Basis of this breakdown

1. Bulletin 3 (M-529 / M-530 / M-531, revision 4, 08/10/2026) was issued after the ductwork in the affected areas had been fabricated and installed per the Addendum 1 drawings. The change therefore includes **disconnecting and removing installed ductwork**, in addition to fabricating and installing the revised work.

Snowflake Fitout - 7 Times Square, Floors 29-31 | COP-SF-05 Bulletin 3 Revision

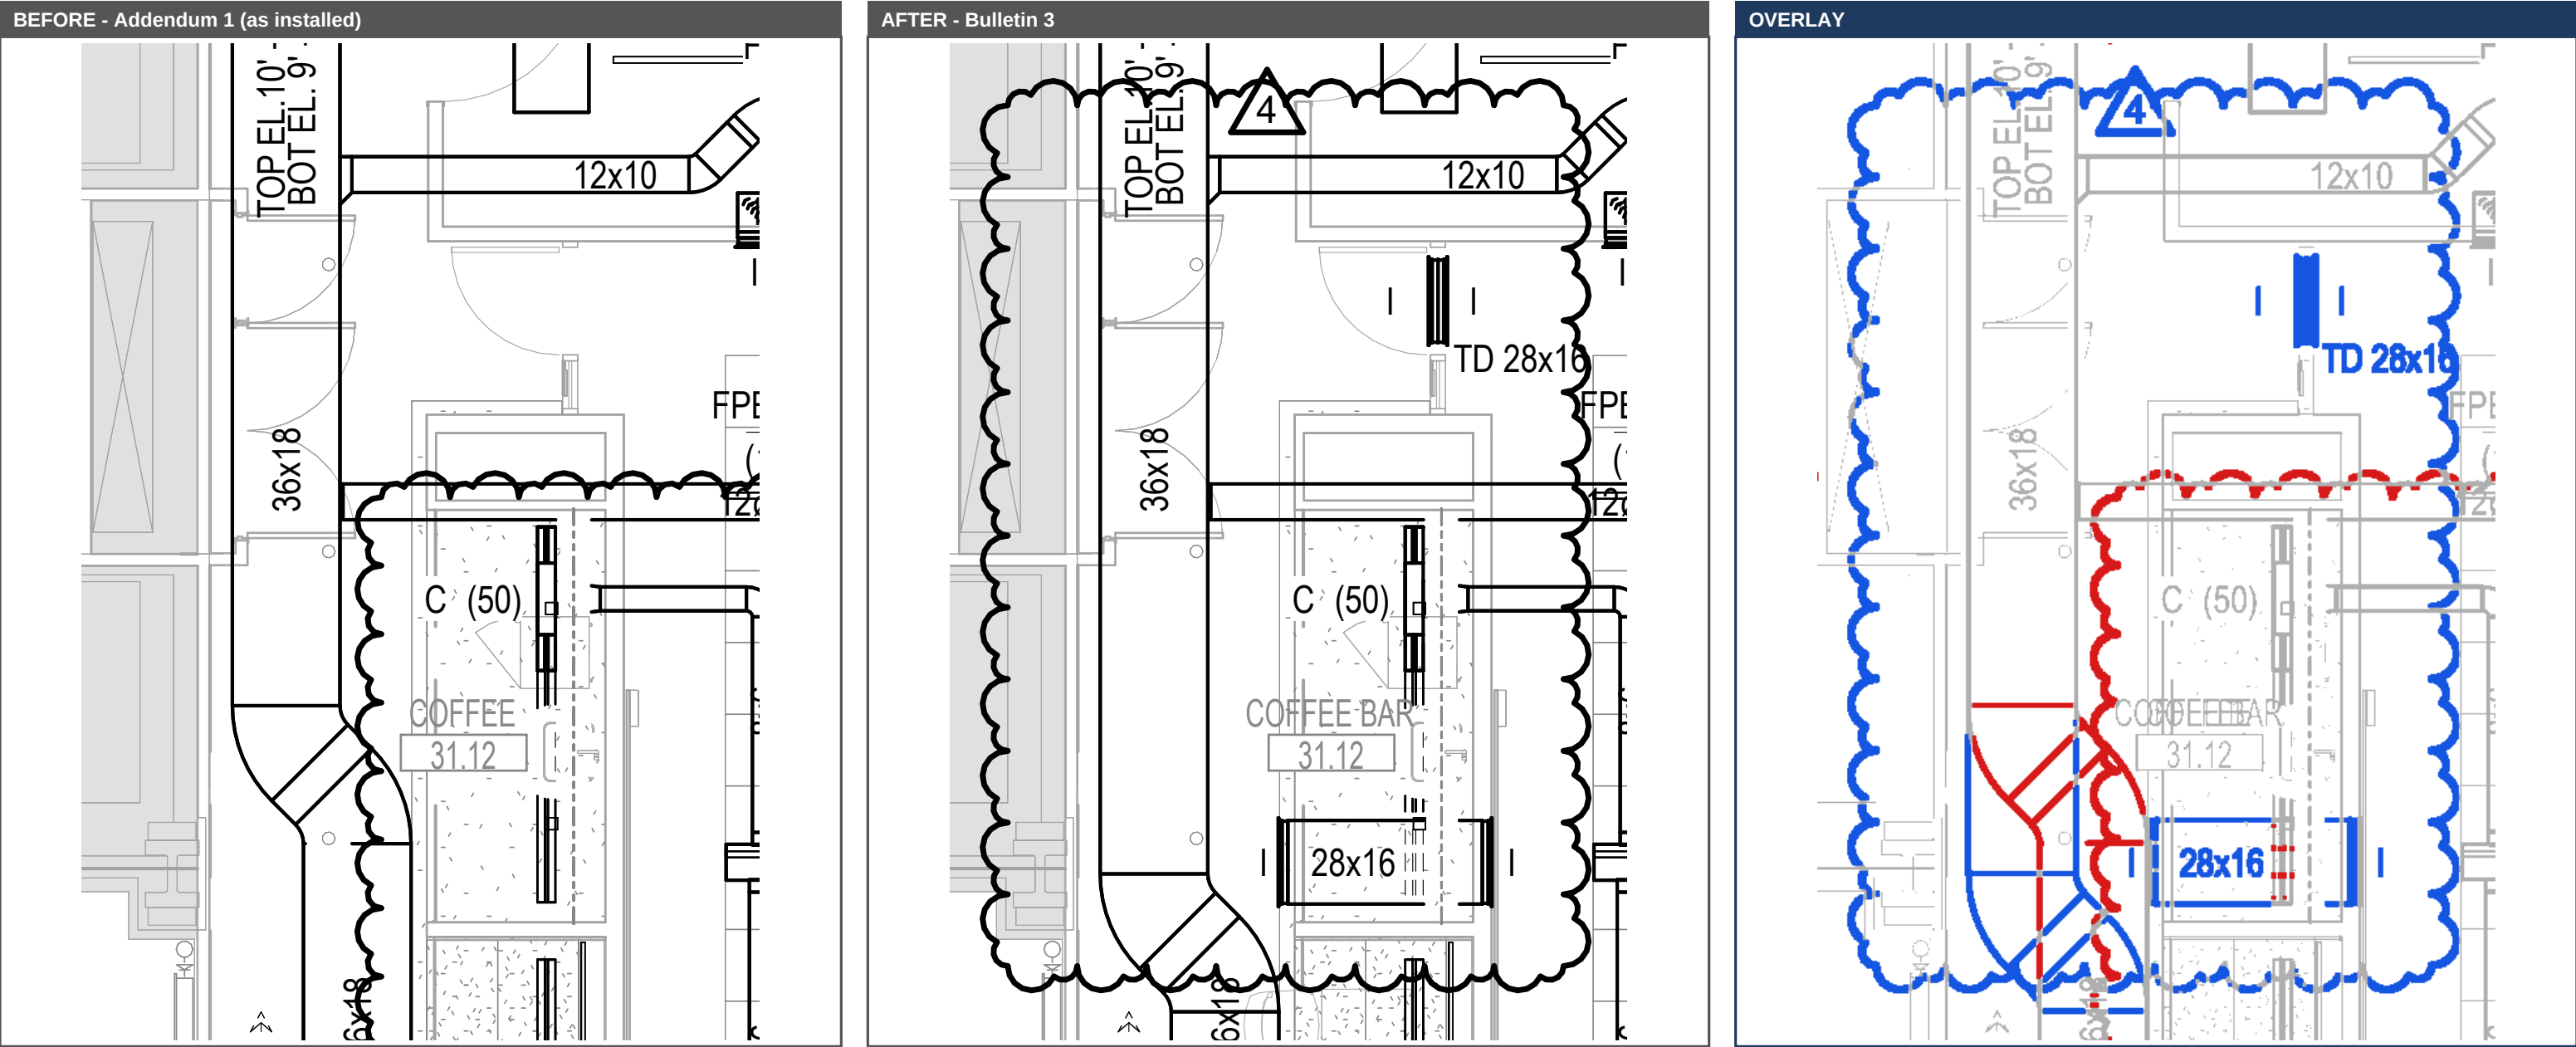
Before (Addendum 1, installed): 36x18 main with elbow at Coffee Bar 31.12; no transfer ducts.

After (Bulletin 3): (2) new TD 28x16; 36x18 main elbow reconfigured.

Work required: Disconnect and remove 36x18 elbow; fabricate and install new fitting and (2) TD 28x16.

Area 31-5 - Transfer duct TD 32x16, southwest

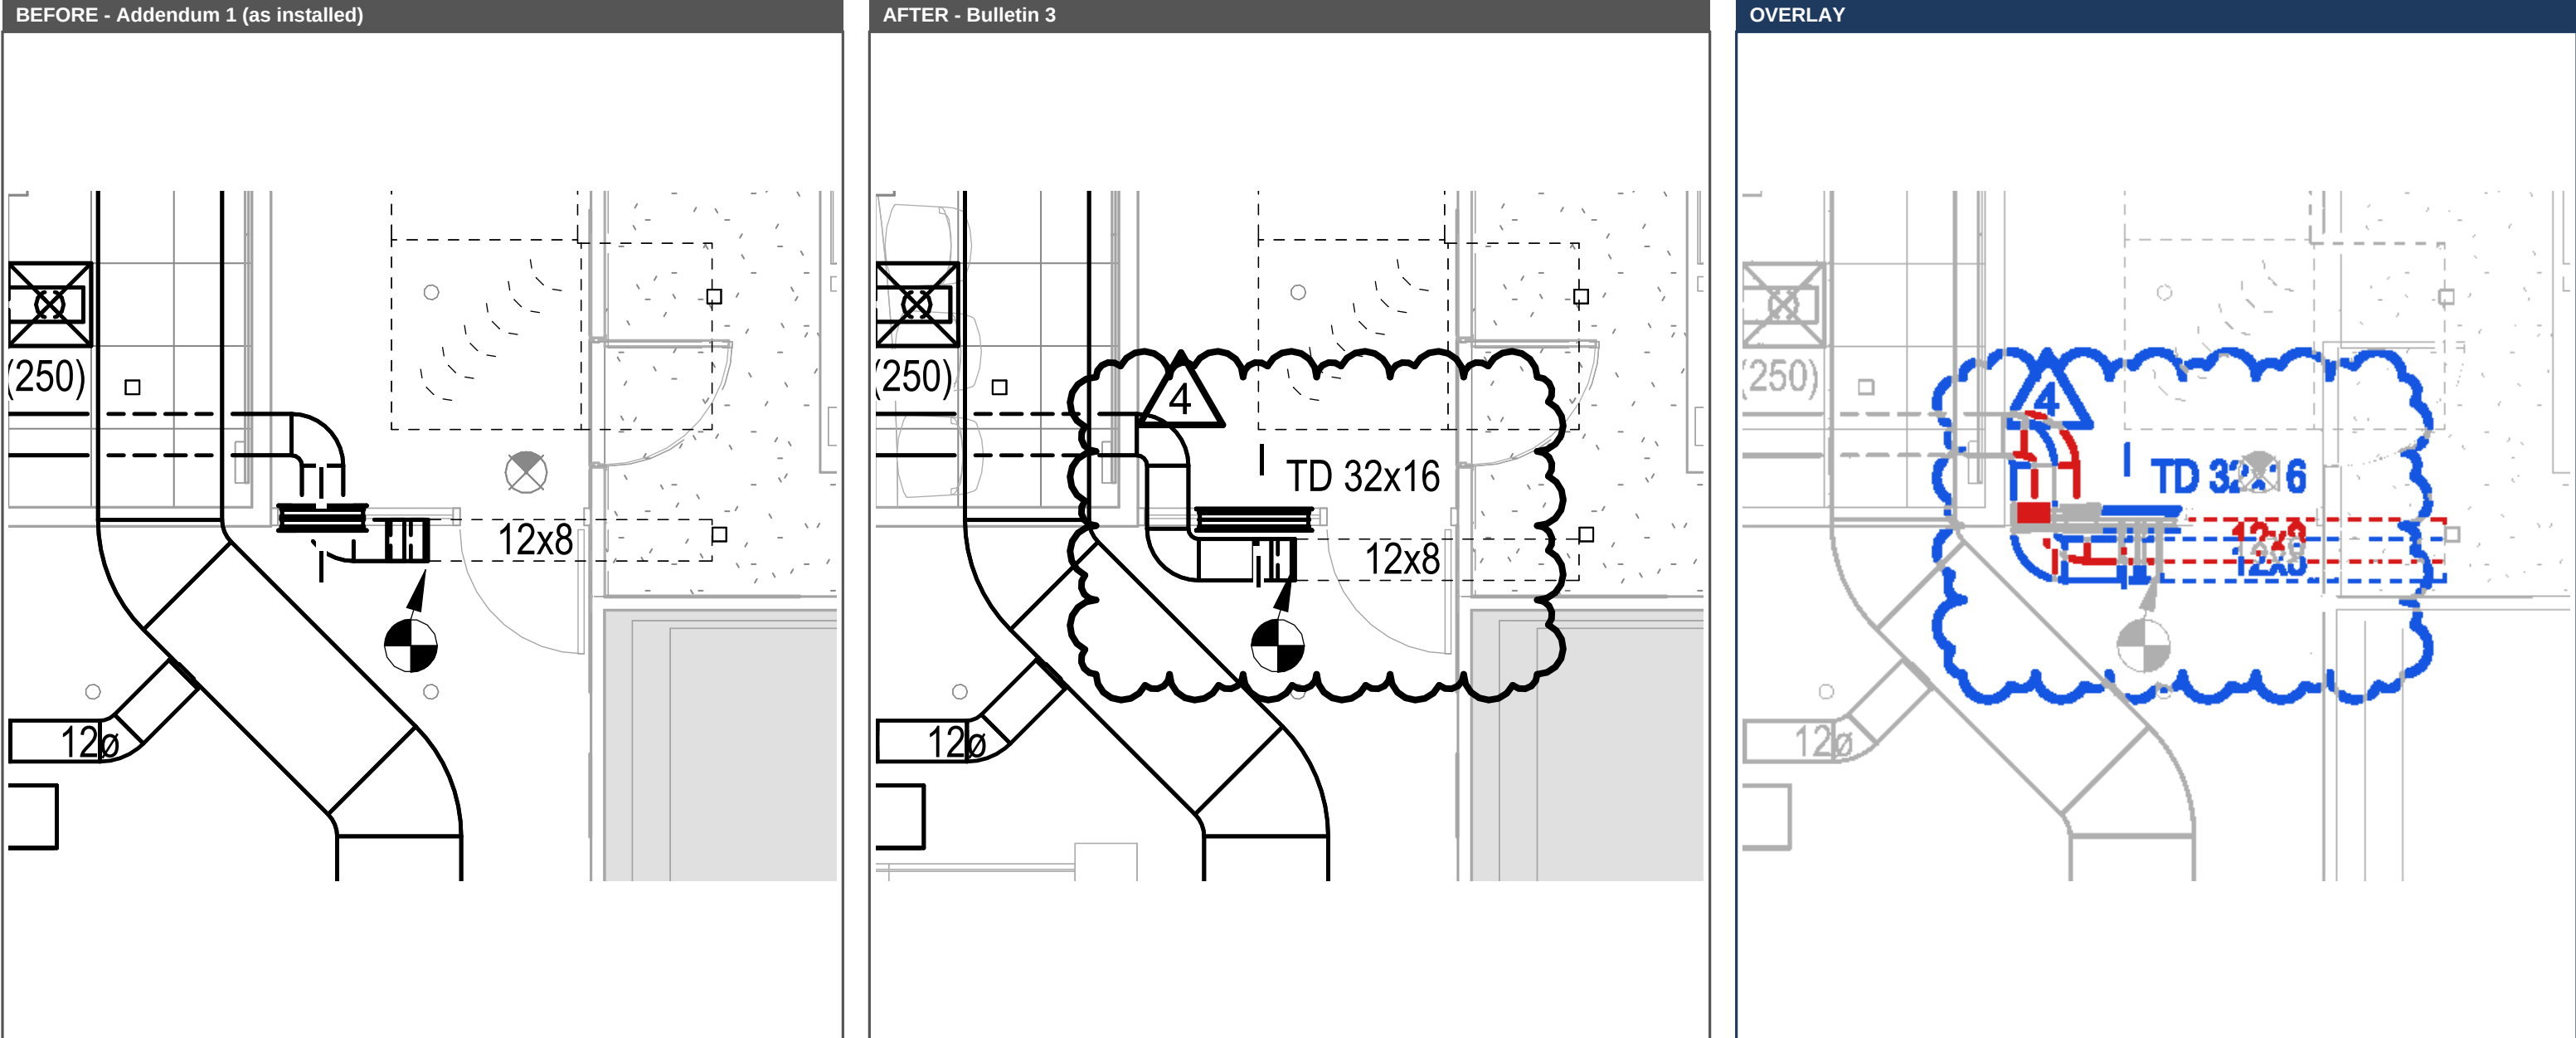
Before (Addendum 1, installed): Transfer duct and duct elbow as installed per Addendum 1, next to the 12x8 branch.

After (Bulletin 3): Transfer duct revised to TD 32x16; elbow deleted.

Work required: Remove installed transfer duct and elbow; fabricate and install TD 32x16.

AFTER - Bulletin 3

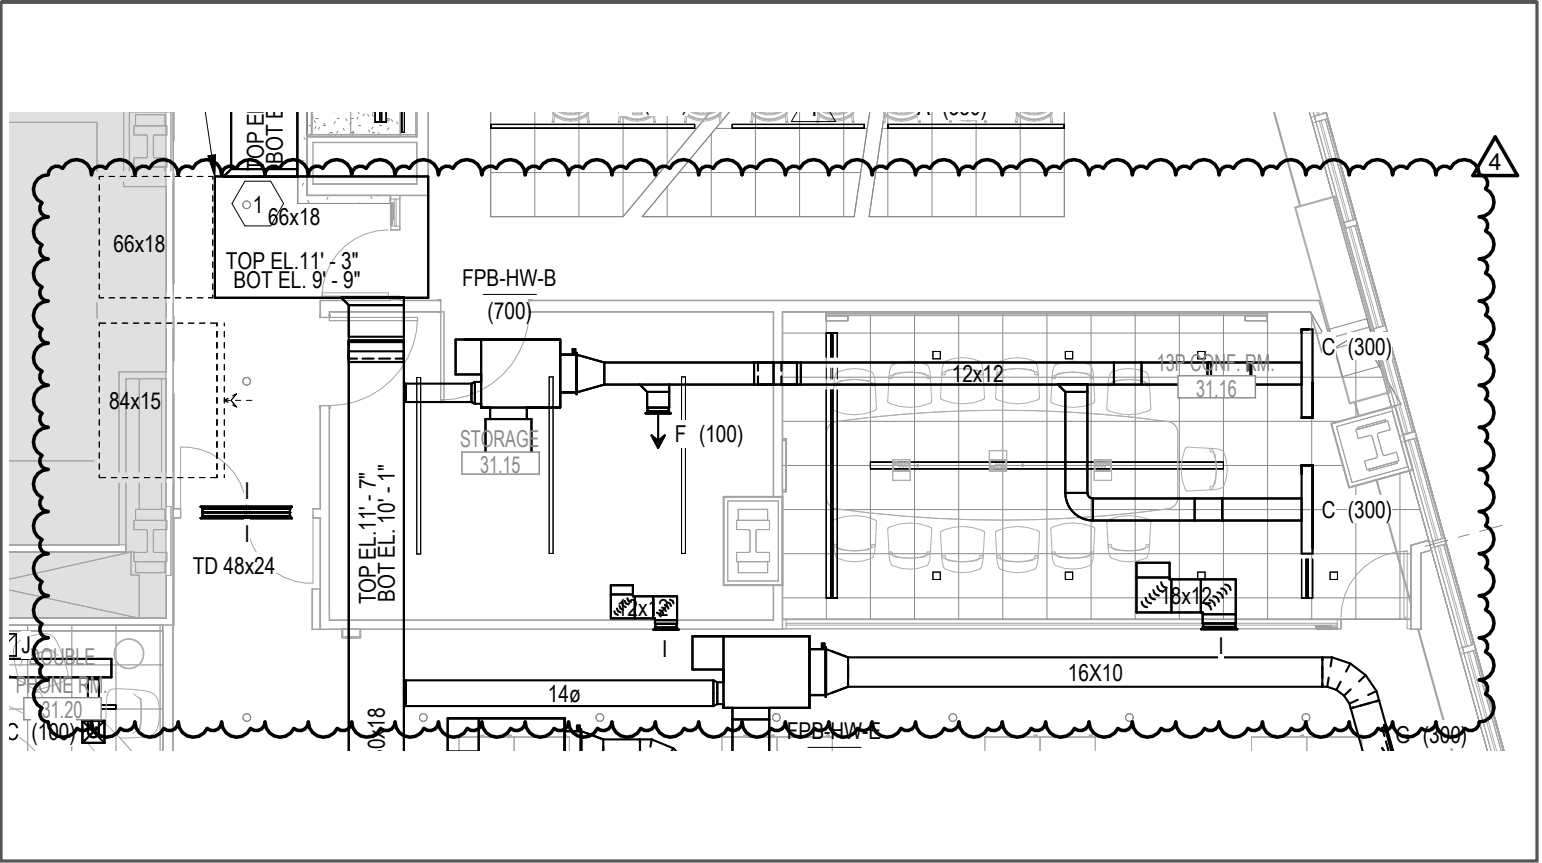
Before (Addendum 1, installed): 12x12 and 18x12 grilles at previous locations; no transfer duct at Storage 31.15.

After (Bulletin 3): New TD 48x24; 12x12 and 18x12 grilles relocated.

Work required: Remove grilles and their duct connections; fabricate and install TD 48x24, relocate 12x12 and 18x12 grilles with duct connections at new locations.
